Firmware Updates Information 17.02.2013

Version 2.90 – published 17.02.2013

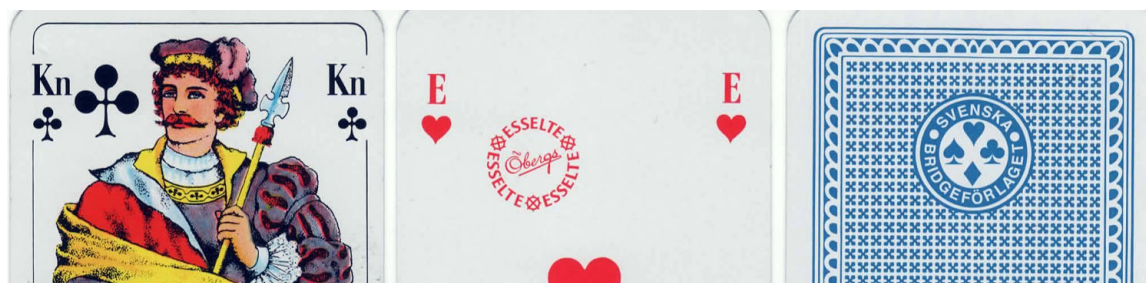
- added recognition for Swedish Svenska Bridgeforlaget cards:

These cards require following settings:

- **Card Index** should be set to **Small**
- **National Settings** should be set to **Swedish**
- **Card Type** should be set to **Standard**
- **Card Font** should be set to **Fine**

Due to the very fine print on these cards it is expected that the number of errors will be higher than normal but it should be possible to deal them.

Version 2.78 – published 12.07.2012

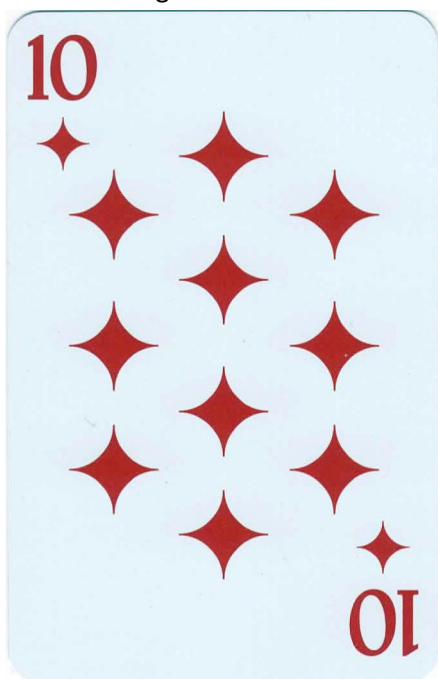
- Corrected a problem with club recognition for Japan Nintendo Cards:

Version 2.58 – published 16.06.2011

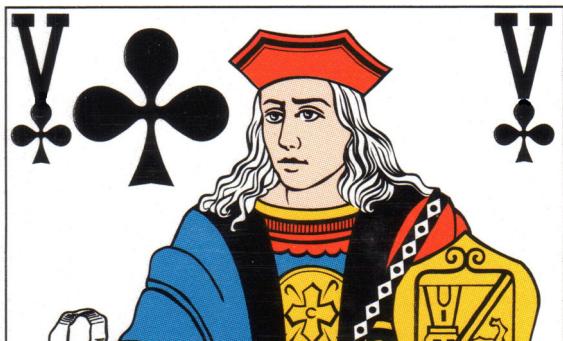
- Improved automatic camera adjustment to make it less sensitive to external light
- Improved recognition of cards with outside frame
- Added recognition of French Bridge Diffusion cards with symbol touching or too close to the suit:
